**R44 SERVICE BULLETIN SB-106**

**R66 SERVICE BULLETIN SB-37**

**DATE:** 21 August 2020

**SUBJECT:** HeliSAS Autopilot Interface with Garmin PFD

**FIGURE 1**

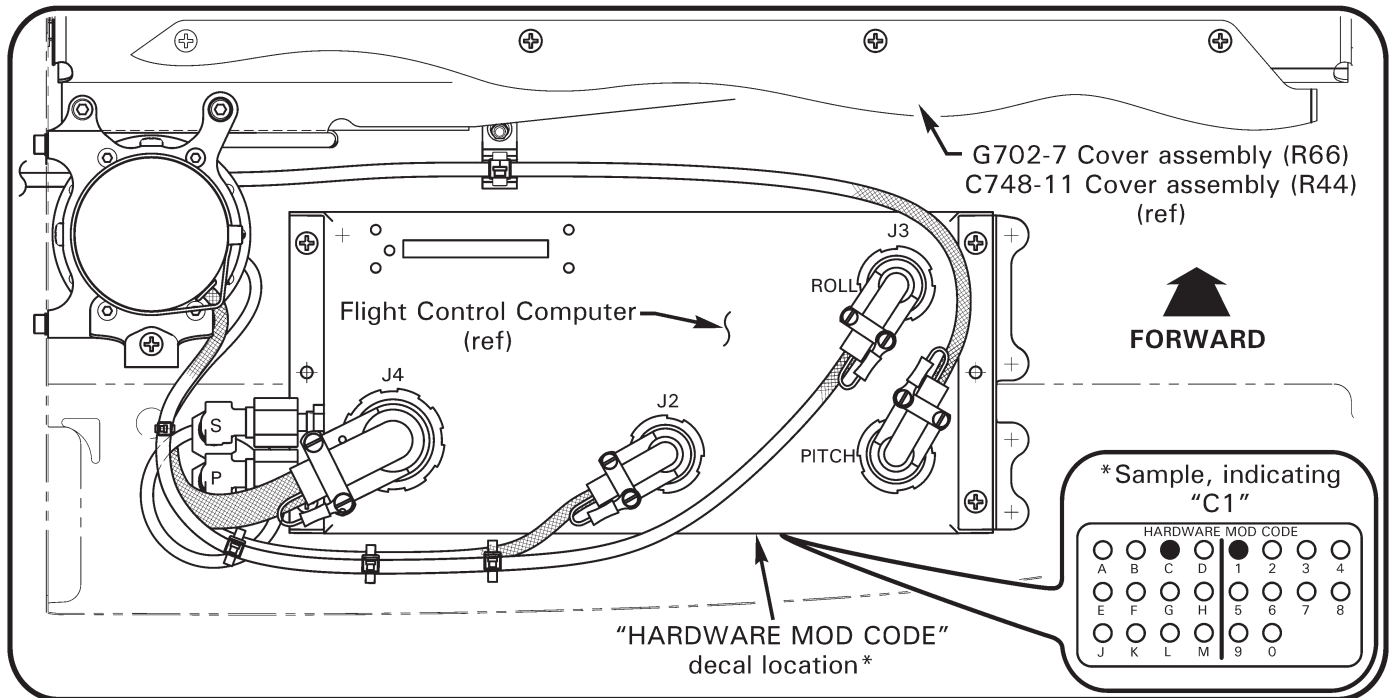
- FCC modification at S-TEC requires approximately 2 weeks.
- Modification level of upgraded unit will be indicated on data plate as shown in Figure 1.

Option A: Return FCC to HeliSAS manufacturer S-TEC for upgrade to FCC Mod "B2" or Mod "C1" (resistors will be added inside computer).
